# 1989 - 1990 Corvette: Service Bulletin: Convertible: Mounting Bracket Rattle at Rear of Hardtop

**Number:** 90-203-10

**Subject:** Mounting Bracket Rattle at Rear of Hardtop

**Model Year:** 1989-1990 Y Car Convertible

**CORVETTE HARDTOP**  
**BRACKET REAR PIN MOUNTING R / L**  
( SERVICE PROCEDURE )

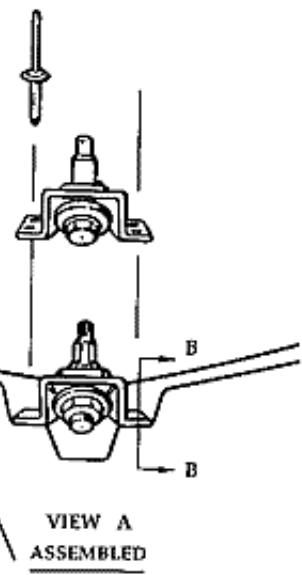
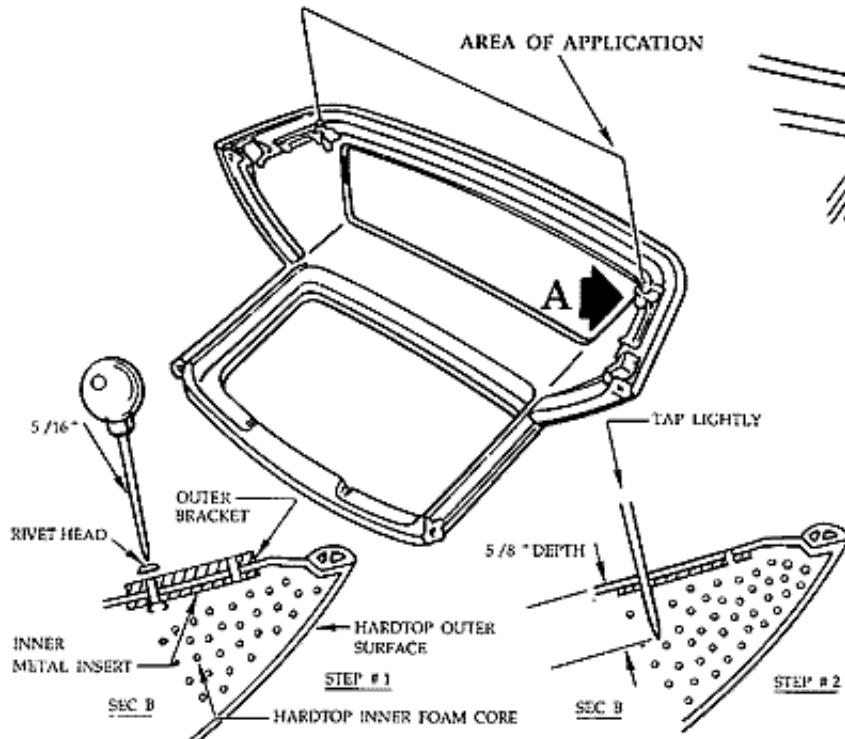
Some 1989 and early 1990 Chevrolet Corvettes (before VIN 106253) equipped with the convertible hardtop option (CC2) may exhibit a rattle at the rear of the hardtop caused by loose hardtop mounting brackets.

Some of these brackets were mounted with rivets which were not long enough to provide enough retention to prevent the rattle.

STEP #1 DRILL OFF RIVET HEADS, USING A 5/16 DRILL BIT,  
AND REMOVE BRACKET. (4 RIVETS PER ASM.)

STEP #2 TAP PREVIOUS RIVET BODIES AND MANDREL 5/8"  
DOWN INTO HARDTOP INNER FOAM CORE AREA.  
(4 RIVETS)

STEP #3 REPOSITION BRACKET AND RE-ATTACH USING  
NEW RIVET ( PN 10064339 )

NEW 1/8" X 1/2"  
STAINLESS STEEL RIVET  
WITH 1/4" HEAD  
PN 10064339
